UNITED STATES PATENT AND TRADEMARK OFFICE

APPLICATION NO.	FILING DATE	FIRST NAMED INVENTOR	ATTORNEY DOCKET NO.	CONFIRMATION NO.
10/089,596	08/16/2002	Javier Puevo Molino	2136OK388	2493

Office Action Summary	Application No.	Applicant(s)	
	10/089,596	MOLINO ET AL.	
	Examiner	Art Unit	
	Meredith C Petrvick	3671

DETAILED ACTION

No. 247,148.

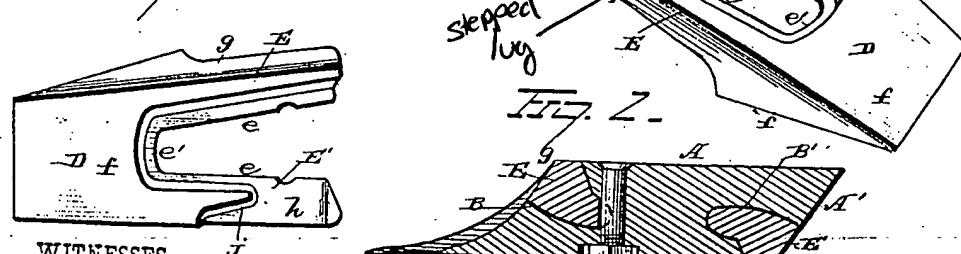
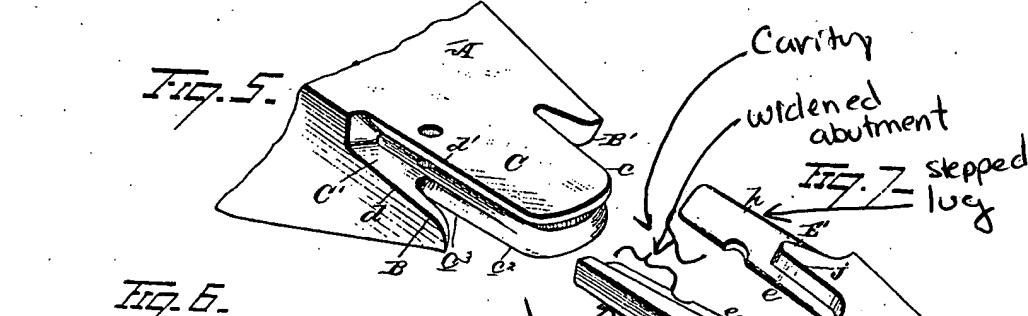
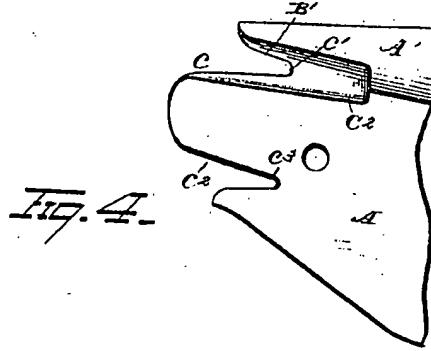
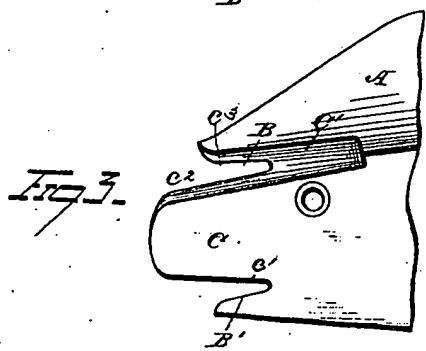
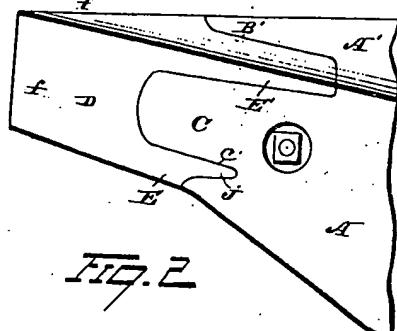
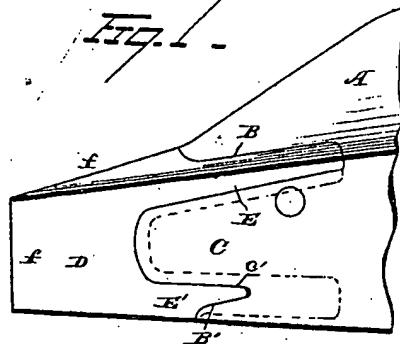
See the attached marked up version of Figure 7 for a detailed explanation of how the art reads on claim 1.

In regards to claims 2-4, the widened abutment regions have portions that are curved (middle portion), an inclined plane portion and a straight step portion (Figs. 6 and 7).

In regards to claim 7, the lugs have a curved shape (Fig. 6).

In regards to claims 8-9, the nose of the tooth holder has a straight guide (C').

In regards to claim 10, the opening for the pin has a chamfer (Fig. 8).
